Addendum No. 2
October 23, 2025

Project: Beresford High School Addition
Beresford, South Dakota
Project #2979

Architect: Architecture Incorporated

3.21A

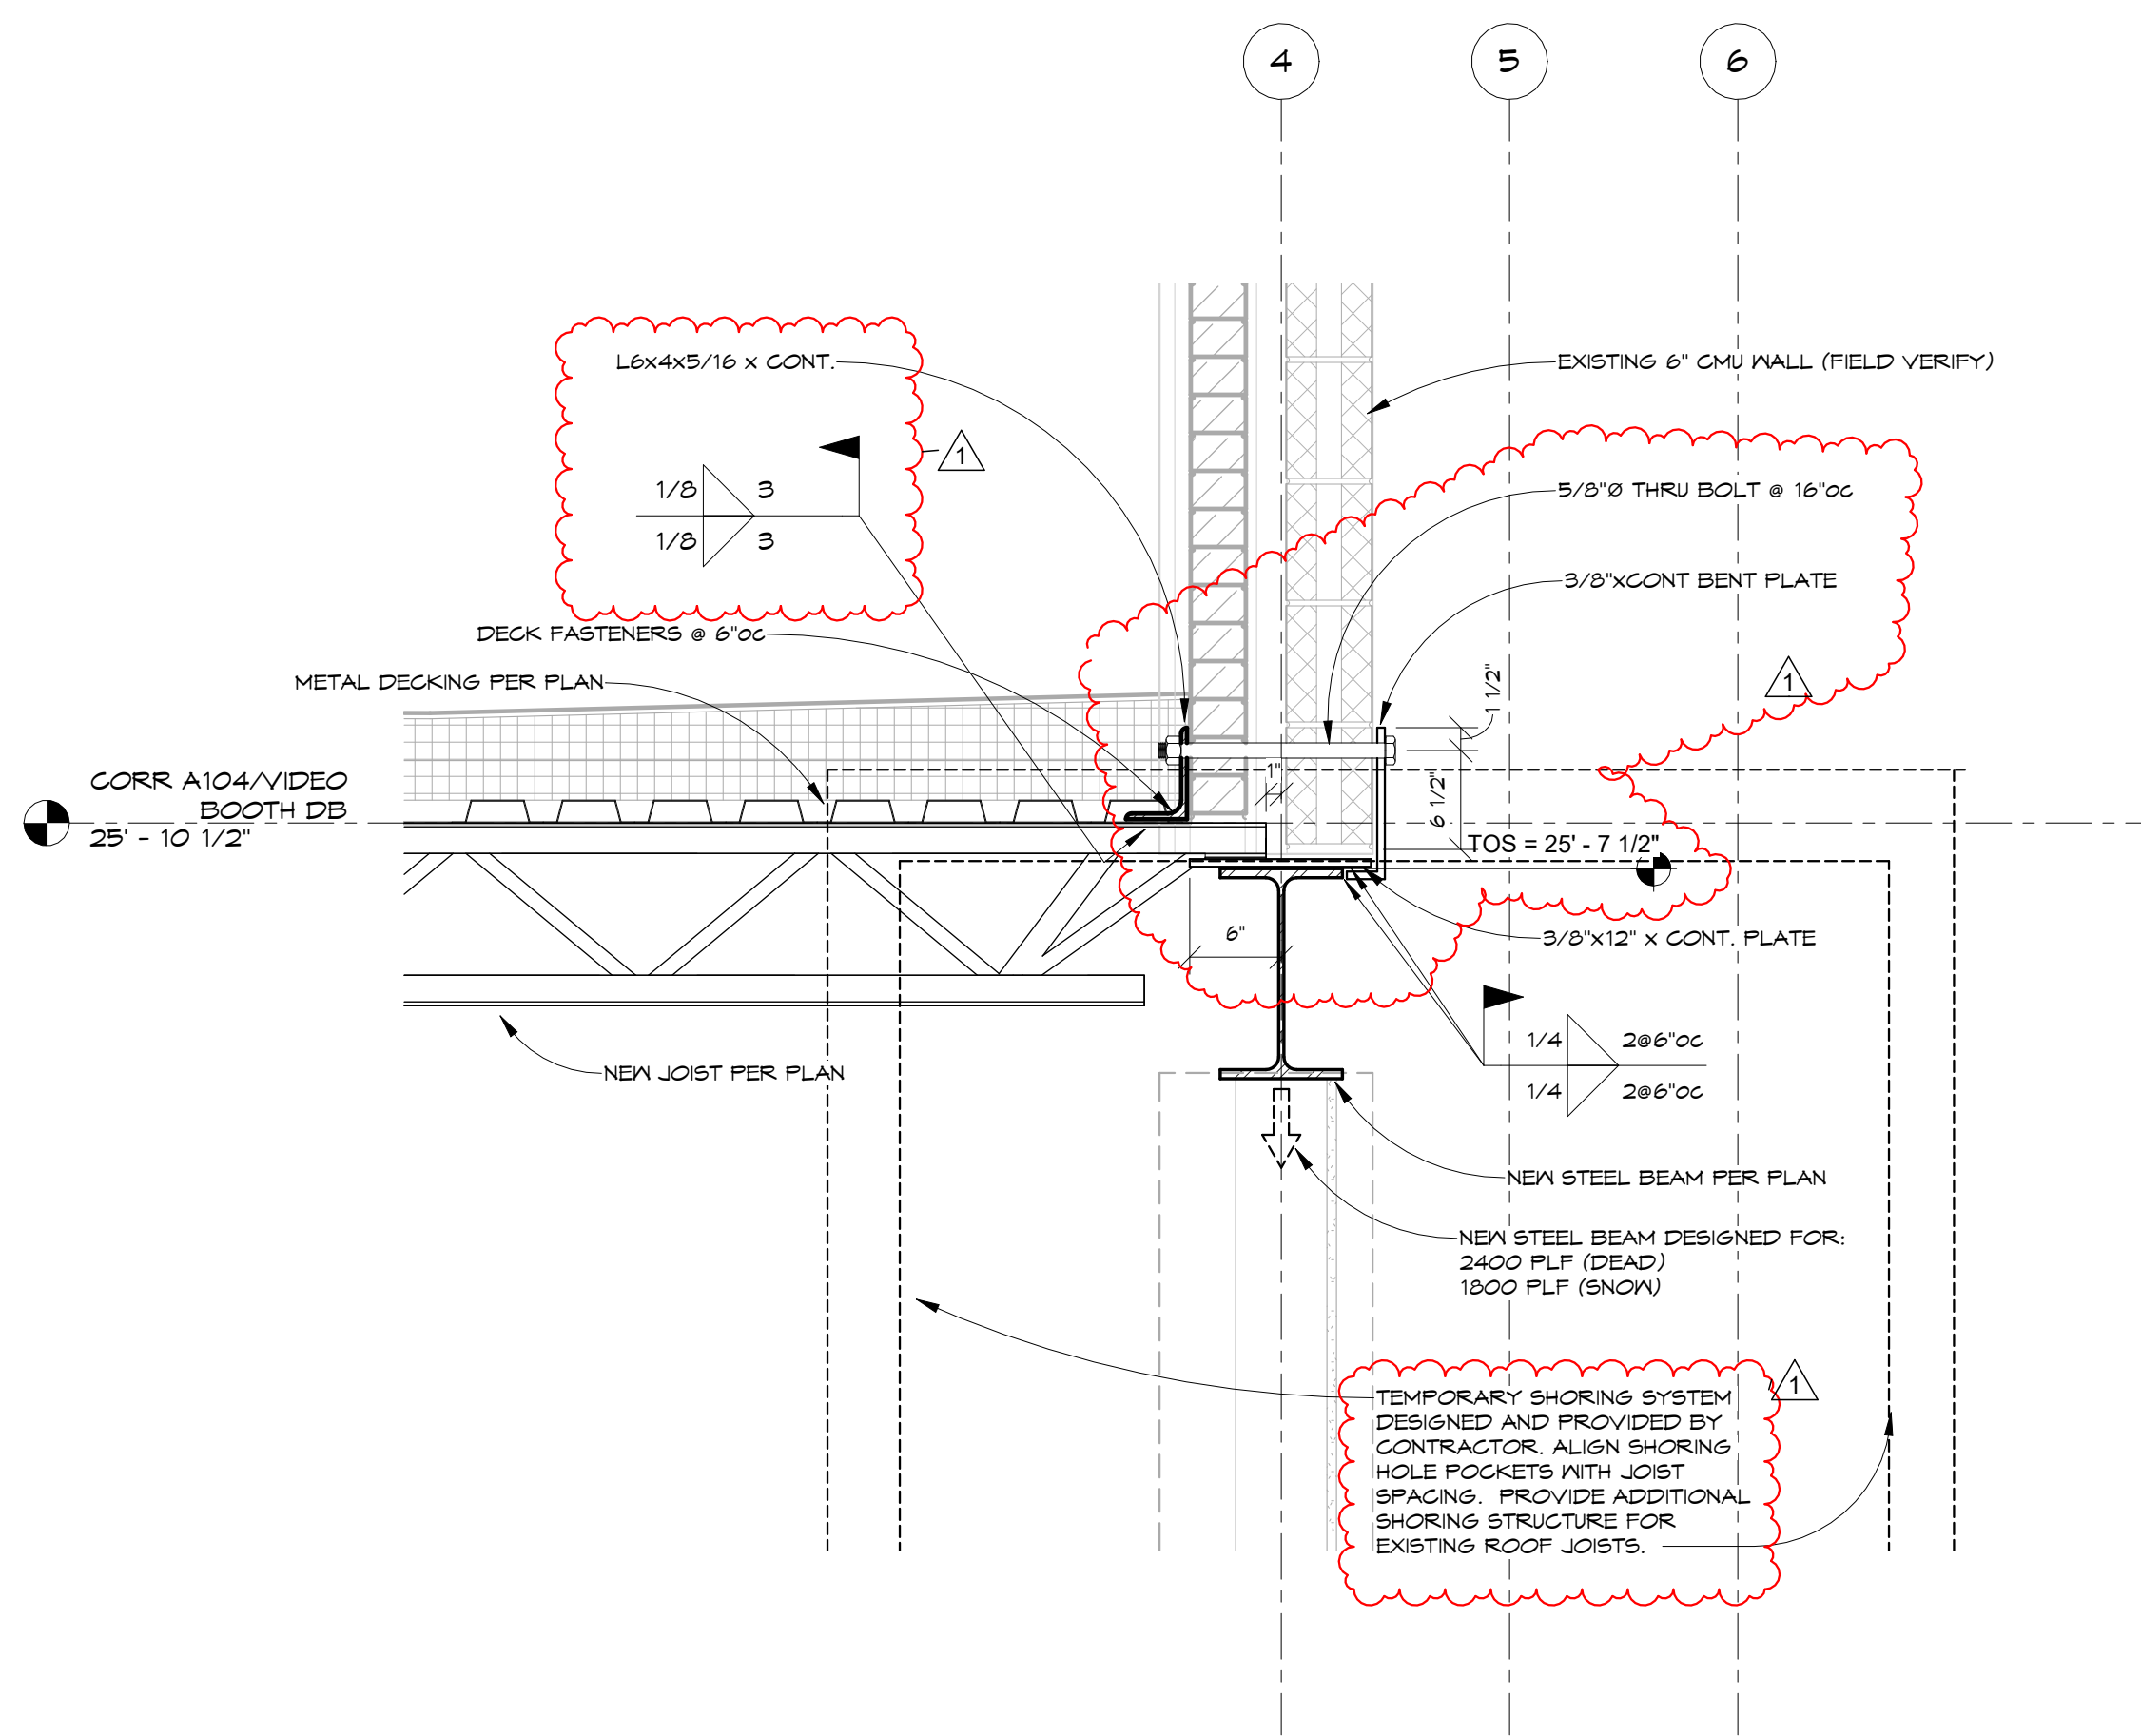
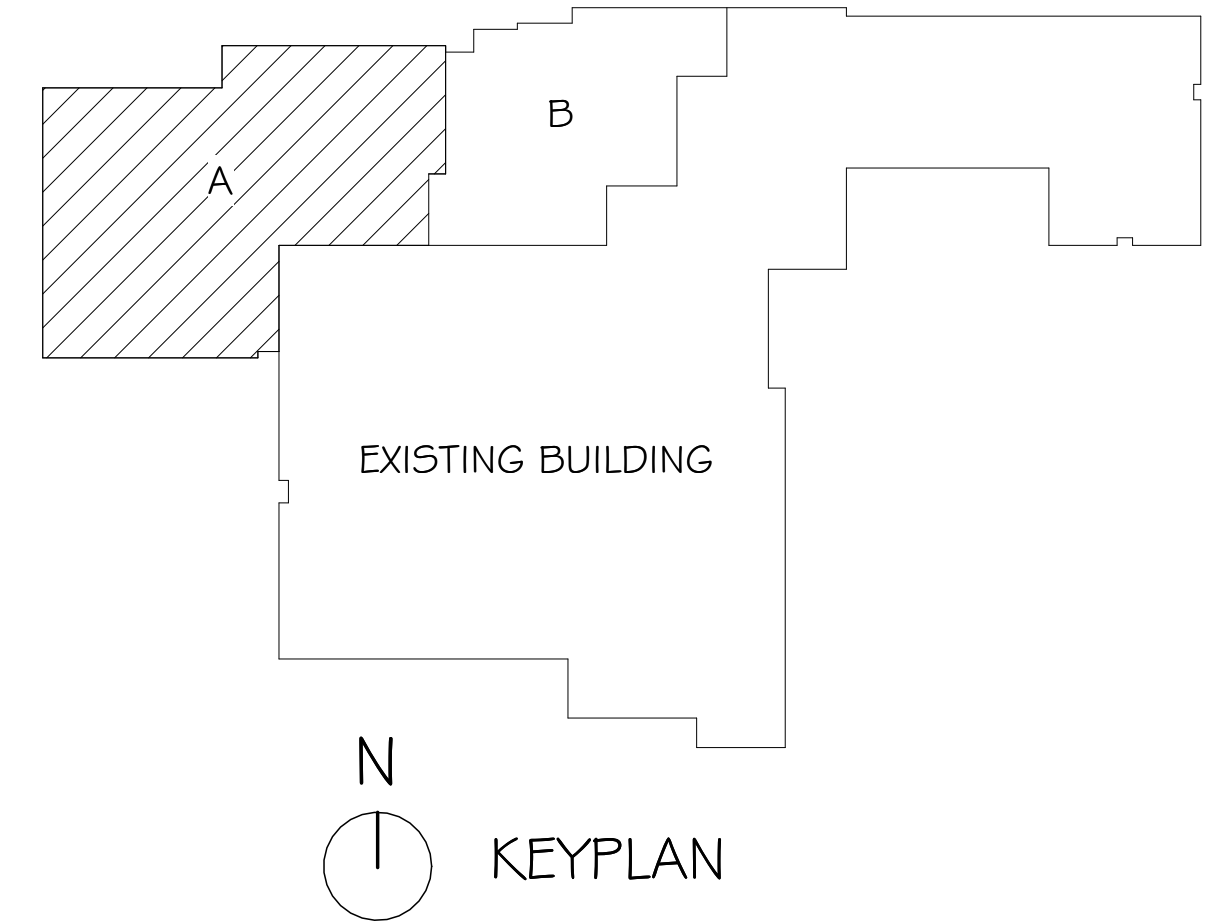
3) SHEET 3.21A – FLOOR/LOW ROOF FRAMING – AREA A

a) Add shoring notes per clouded on the *revised* sheet 3.21A, *revision* dated 10-23-225 attached to the end of this addendum.

1 NEW OPENING IN EXISTING COMMONS WEST WALL
1" = 1'-0"

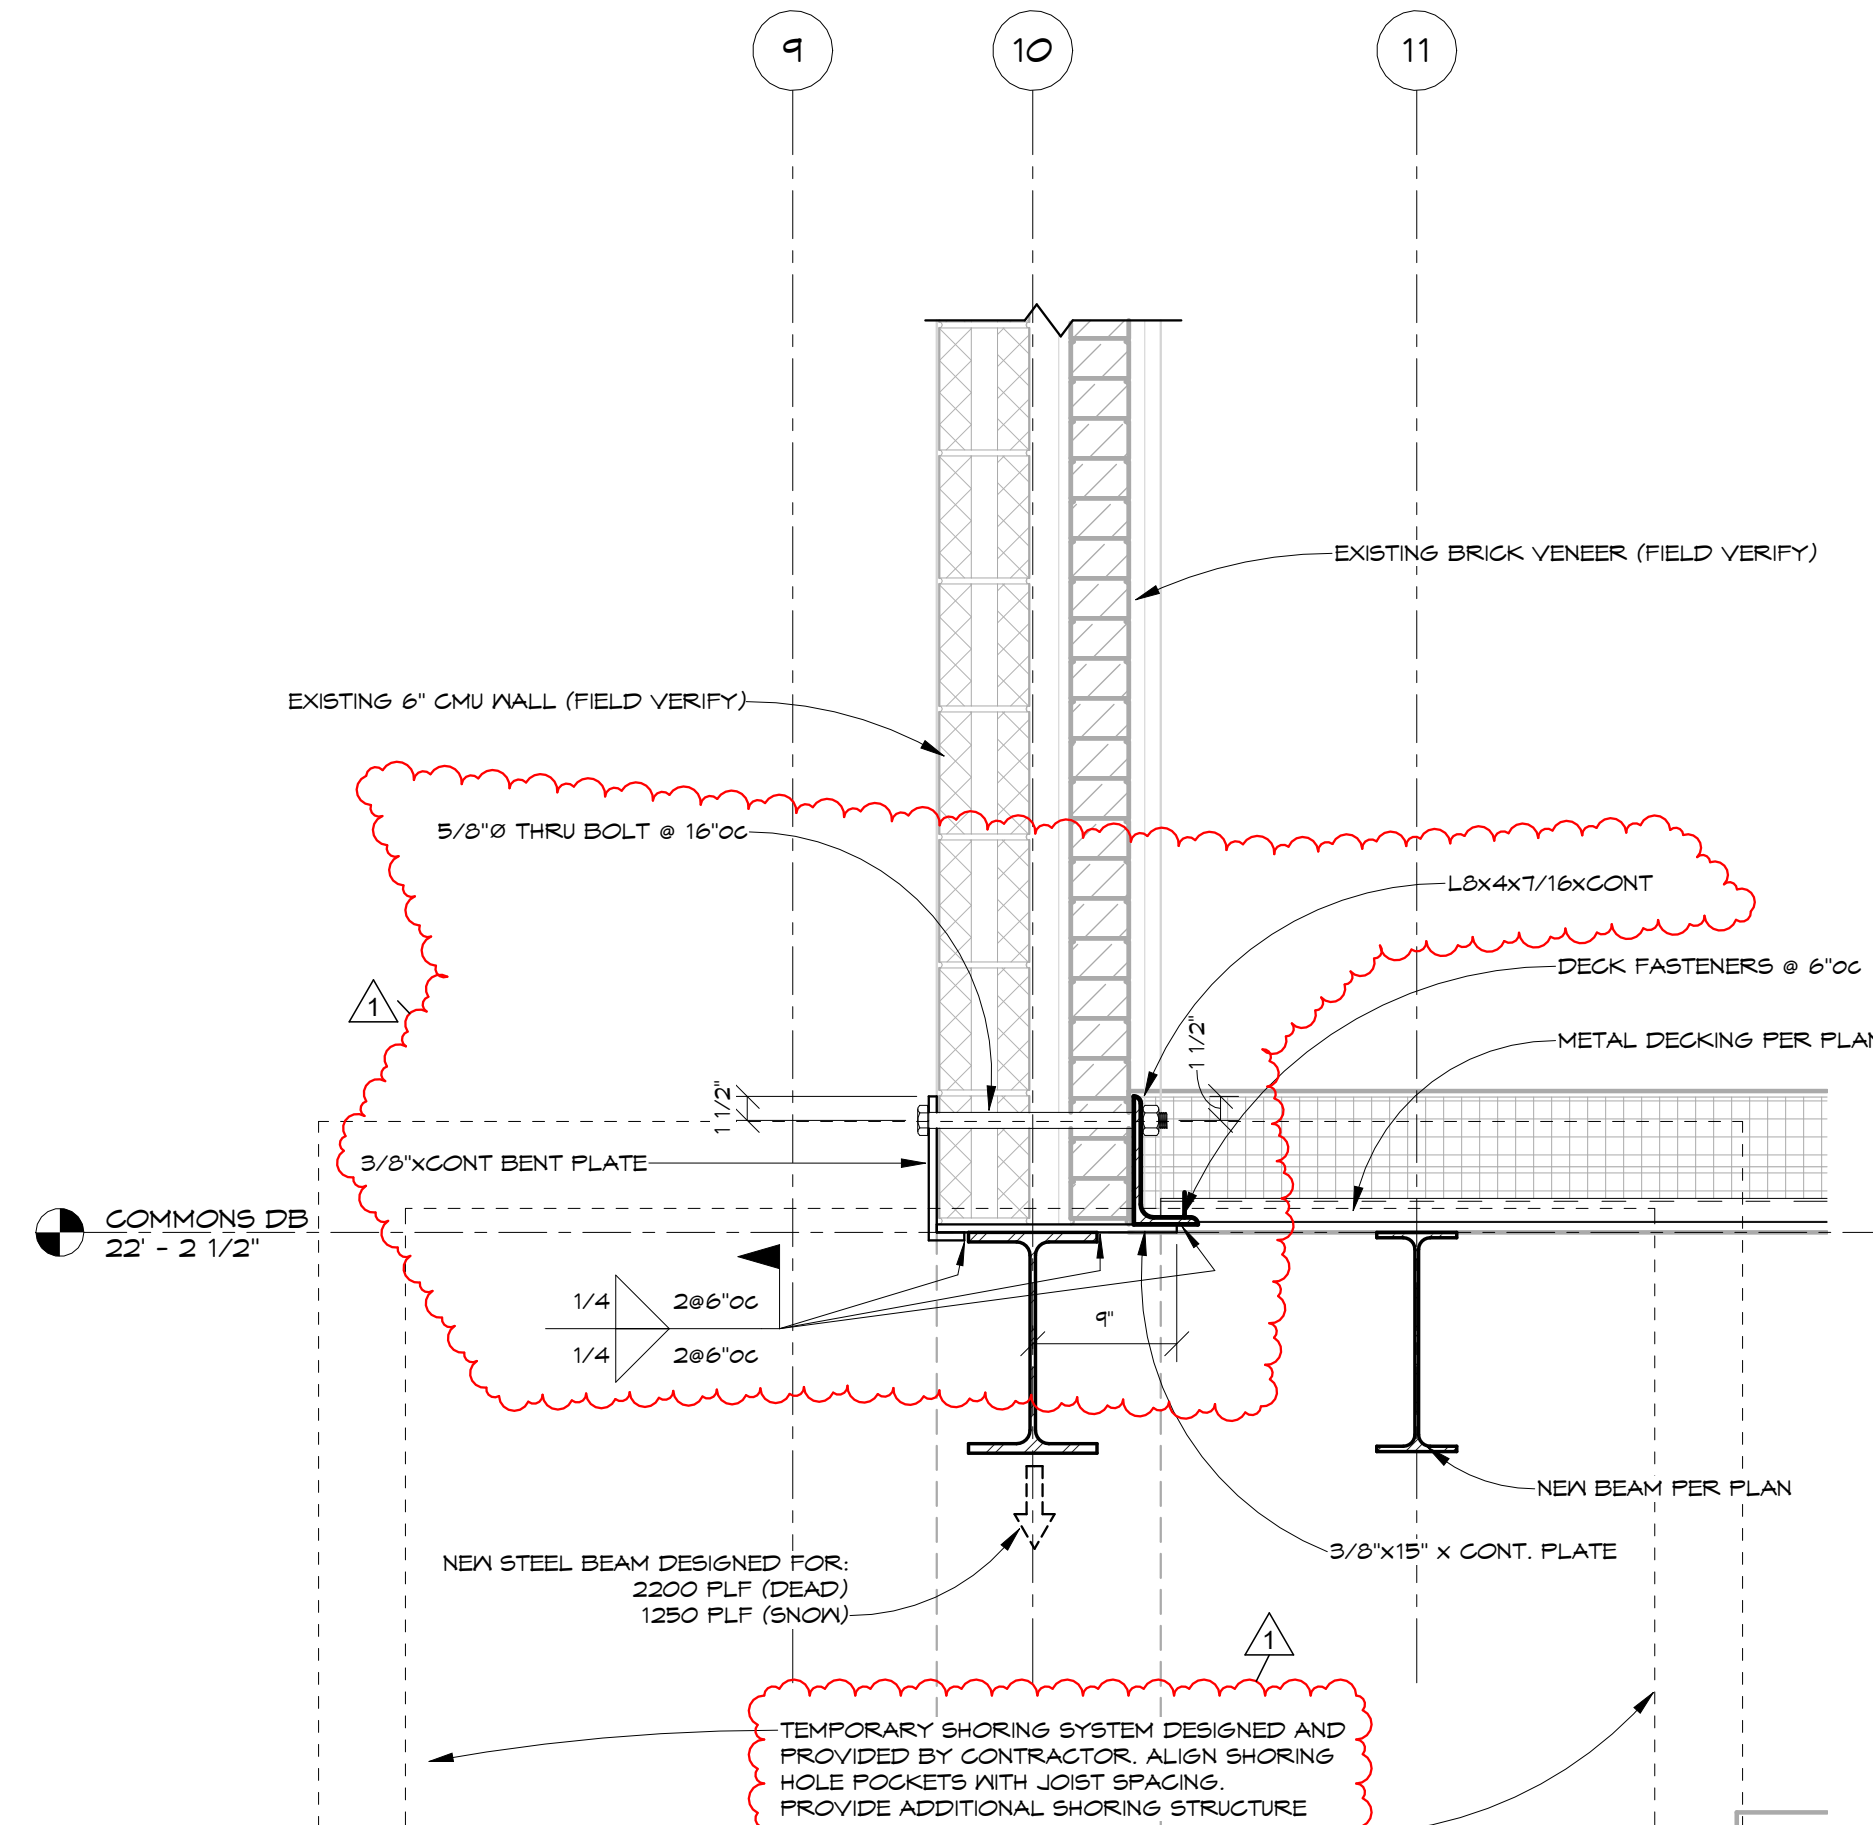
- i) Detail 1/3.59: Add shoring notes and connections per clouded on the *revised* sheet.
- ii) Detail 2/3.59: Add shoring notes and connections per clouded on the *revised* sheet.
